Project: CTM Subdivision

Re: Weber County Engineering Division Review

Weber Fire District Review

CTM SUBDIVISION

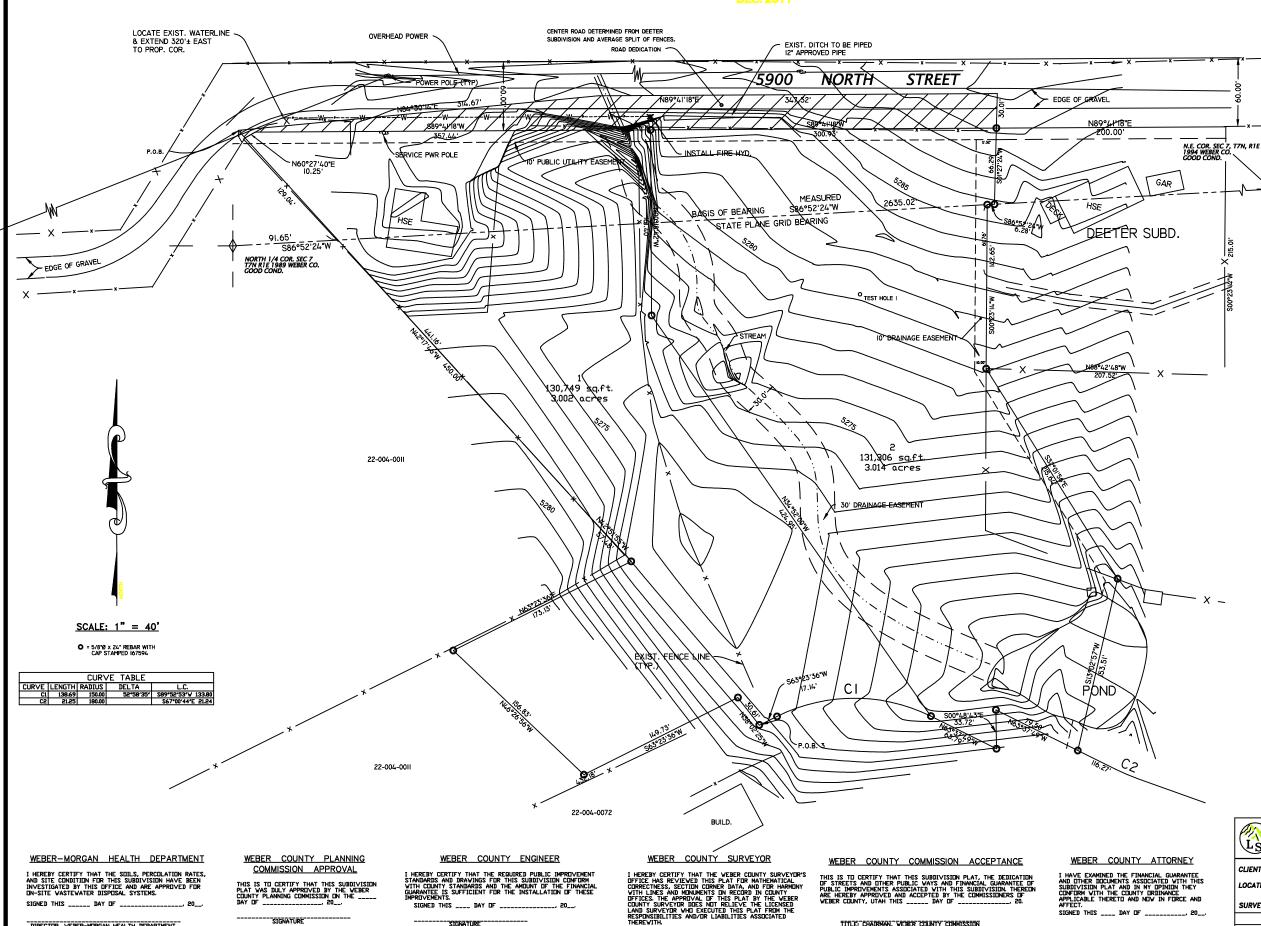
1. The issue with the road alignment has been addressed (see attached plat map)
